MONITORING YEAR 1 ANNUAL REPORT

LONE HICKORY MITIGATION SITE

RE: Lone Hickory Mitigation Site – Monitoring Year 1 Report Final
Yadkin River Basin – CU# 03040101 – Yadkin County
DMS Project ID No. 97135
Contract # 006897

Wildlands Engineering, Inc. (Wildlands) has reviewed the Division of Mitigation Services (DMS) comments from the Draft Monitoring Year (MY) 1 report for the Lone Hickory Mitigation Site. Wildlands' responses to DMS' report comments are noted below in *italics*.

Figure 3.3 Integrated Current Condition Plan View Map (Sheet 3)
 Lone Hickory Mitigation Site
 DMS Project No. 97135
 Monitoring Year 1 - 2019

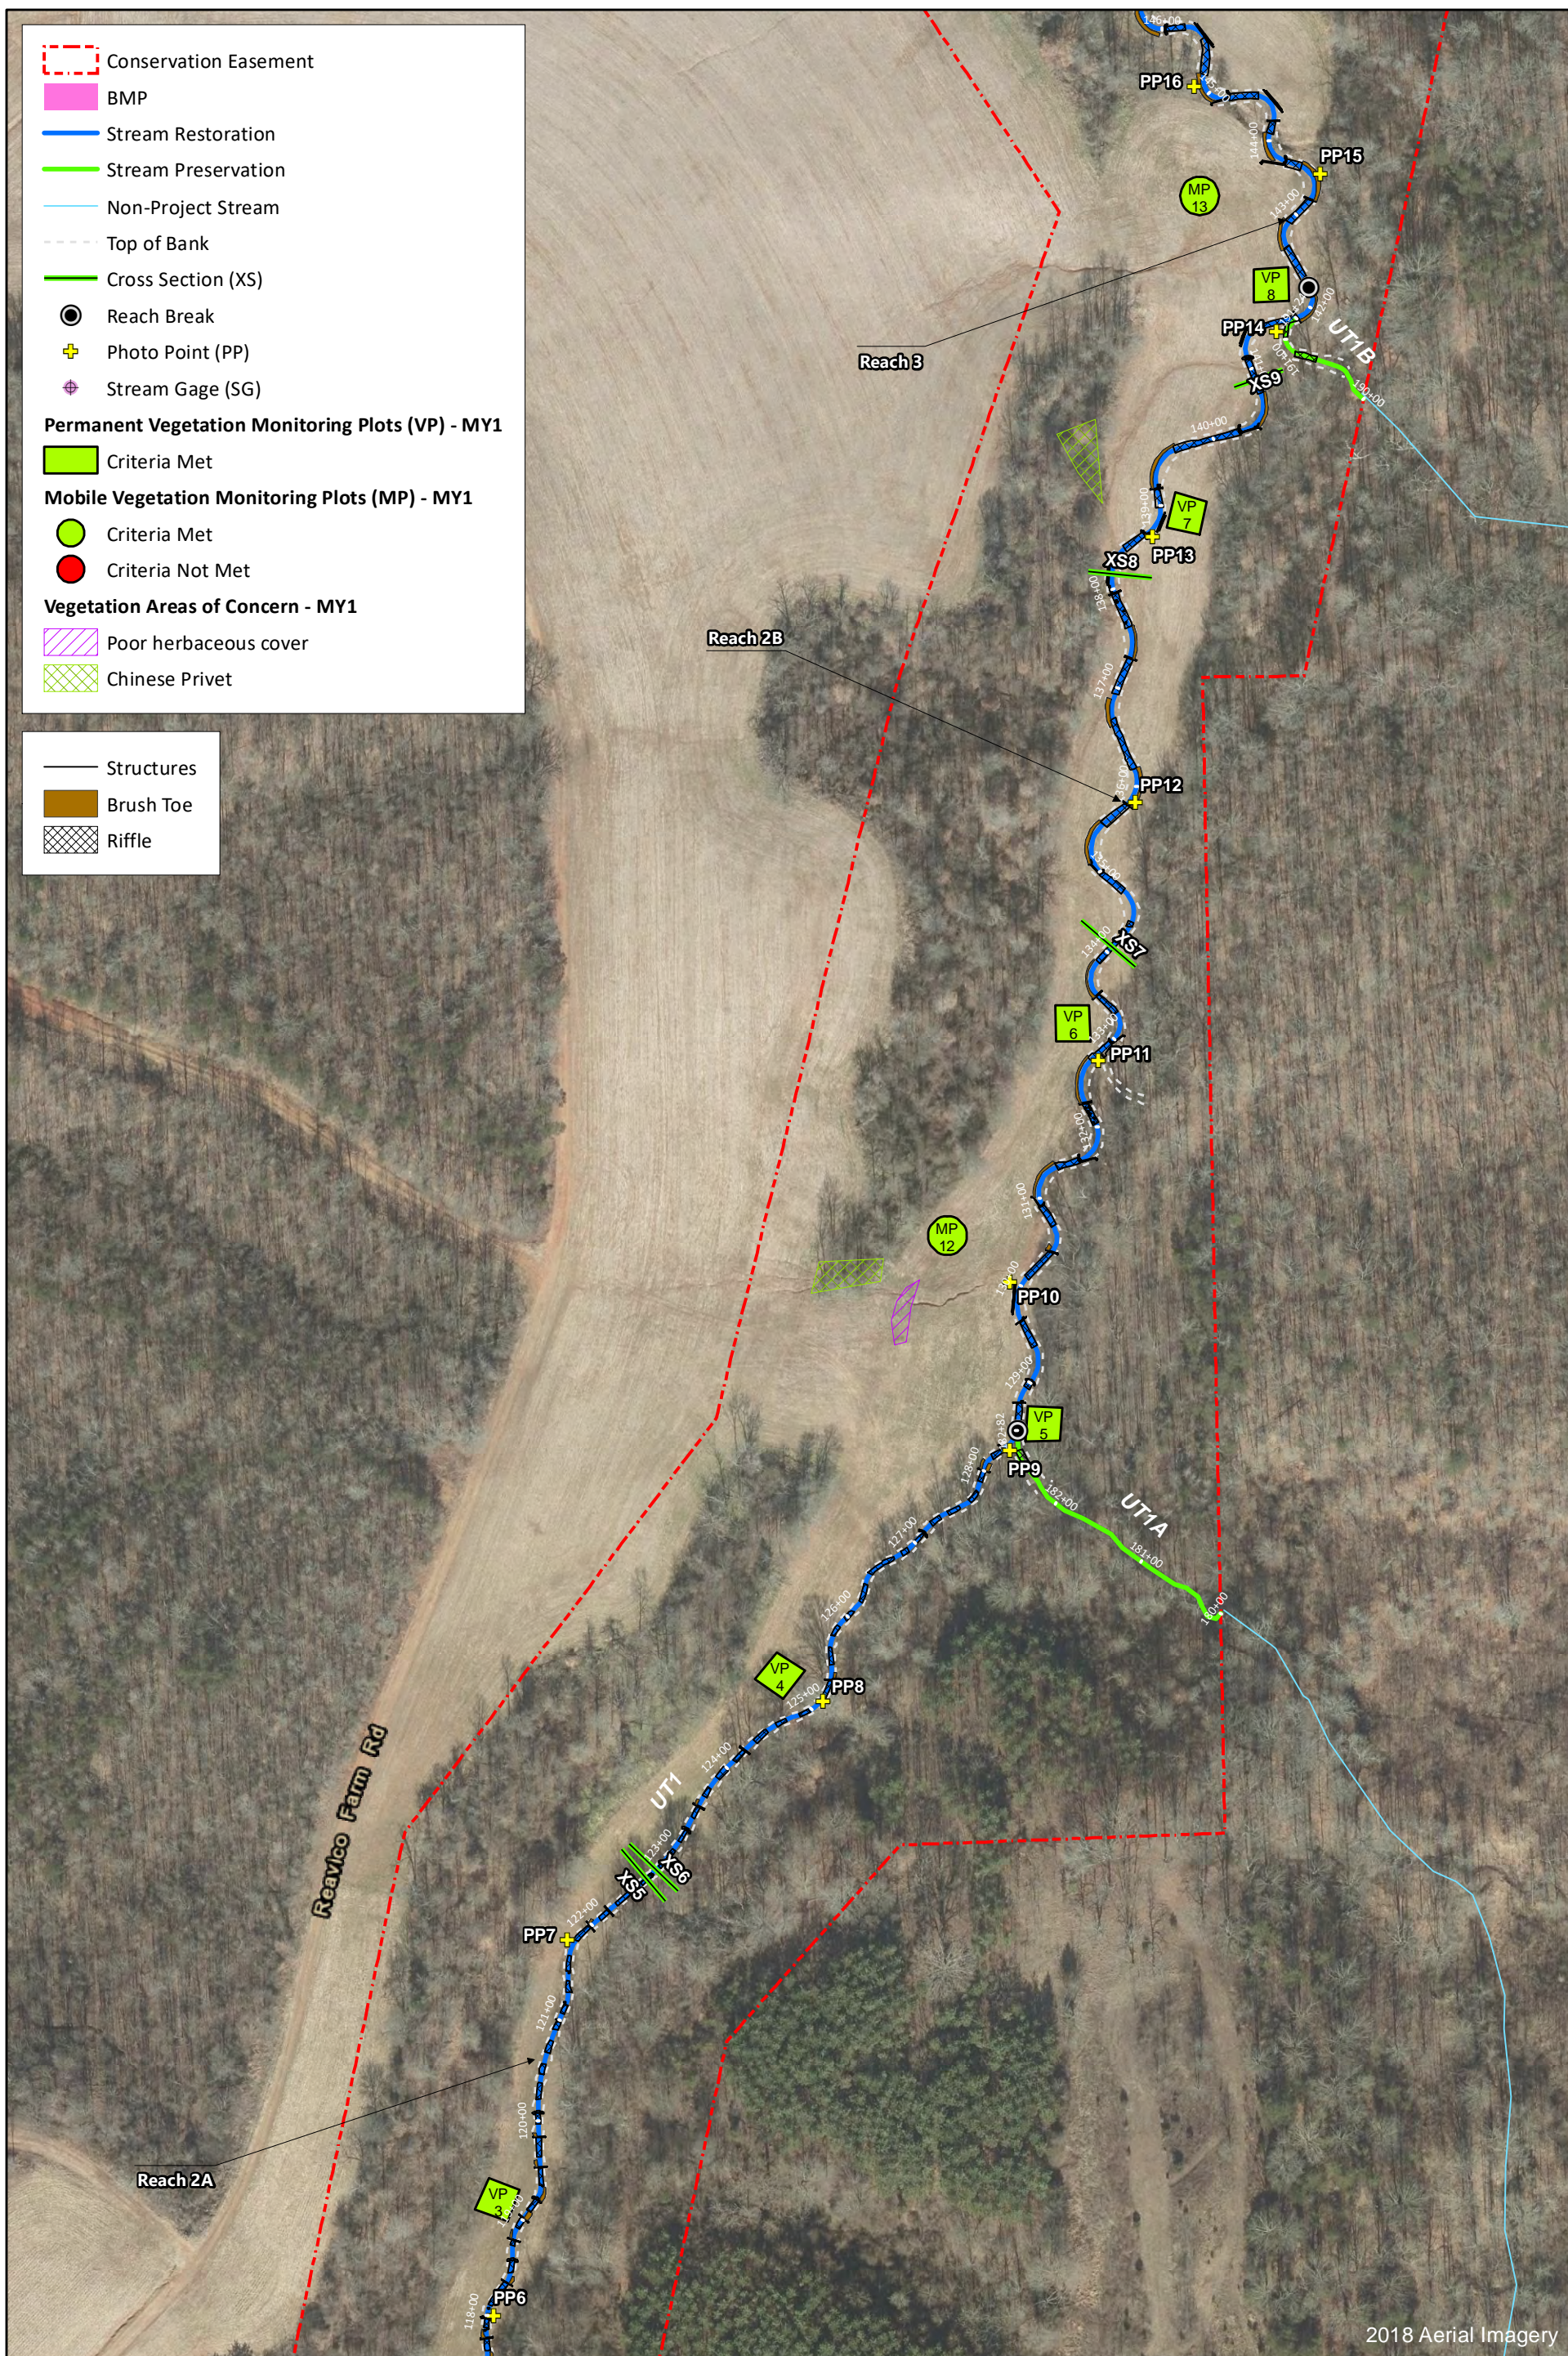
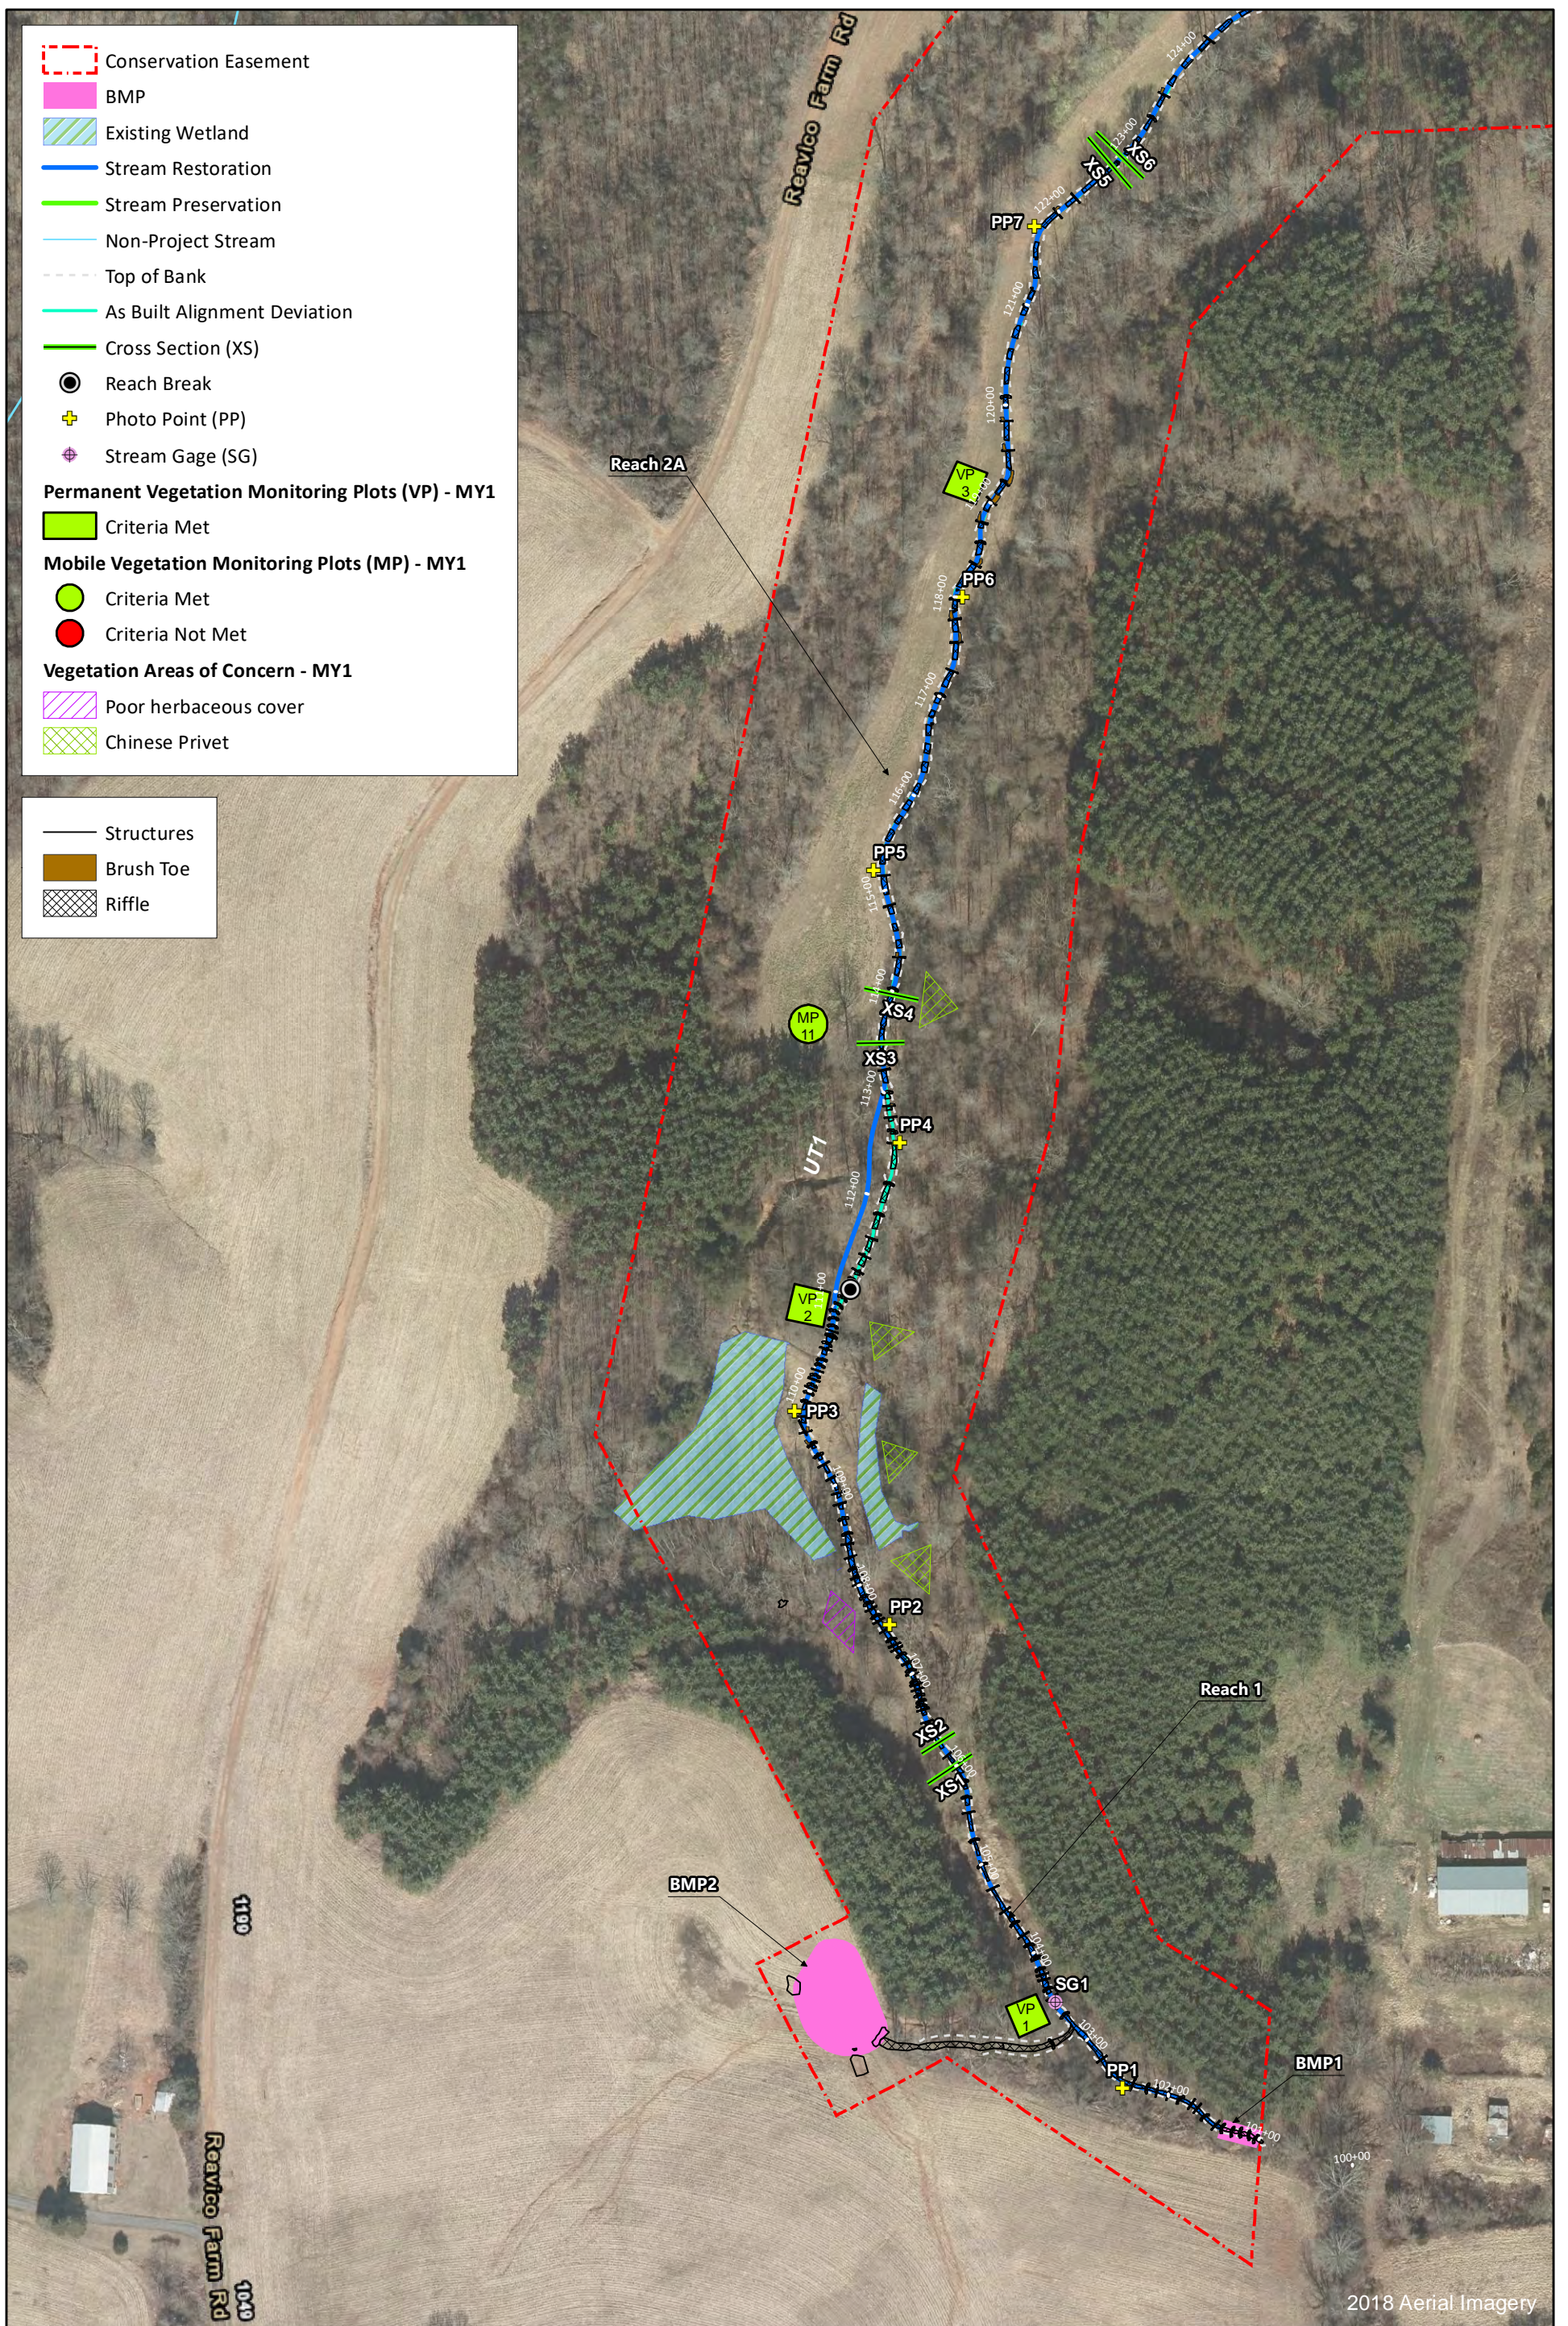
DMS comment; Section 1.2.4 – Stream Hydrology Assessment & CCPV Maps: Do the CCPV maps show the October 2019 relocated stream gages on UT2A and UT2B or the MY0-MY1 gage locations? Since these gages were not relocated until October 2019, DMS recommends showing the previous MY0 locations in the MY1 report and updating the mapped locations (and digital support files) in the 2020 - MY2 report. Please address and update the report text accordingly.

Wildlands response; The CCPV maps submitted with the MY1 draft report showed the relocated stream gage locations on UT2A and UT2B. The CCPV maps and digital support files have been updated to show the previous MY0-MY1 stream gage locations on UT2A and UT2B and text has been added to section 1.2.4. Going forward, the MY2 report will show the relocated stream gage locations.
